Gloucestershire Spine Link. Section 2, Phase 1 - A435 Cycleway.

Cheltenham Racecourse GWSR Bridge to Bishop's Cleeve Roundabout

Objection - Not Beneficial for Walkers, the Countryside and Cyclists - 26 Feb 2024

Hyde Brook Bridge.

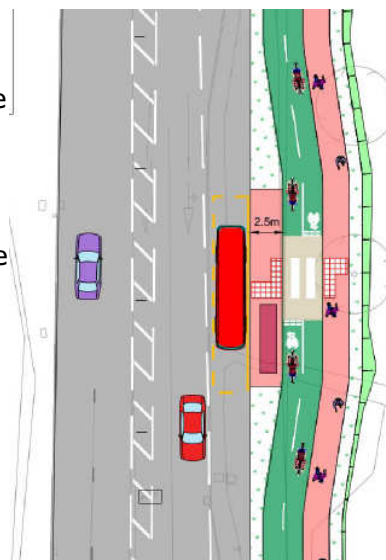
A bridge parapet wall is to the left west side of the pavement between the Southam and Garden centre signs. The other parapet wall is apparent to the right of the right east verge. The raised kerbs help protect pedestrians and the parapets from motor traffic.

The proposal is to remove the pavement on the left, move the carriageway left and and try to squeeze in a shared use cycleway between the relocated carriageway and the right parapet. The risk of collisions, between cyclists and walkers, can be increased by shared use and which already appears high considering the number of miles of shared use.

Gear Change instead favours segregation to avoid conflict.

Suitable options might include:

- A footbridge over the Brook to the left of the parapet. The fence is on highway space.
- A precast concrete box culvert dropped into the Brook to the right of the right parapet to carry the cycleway. This could save costs by avoiding the need for realignment of the footway and carriageway.
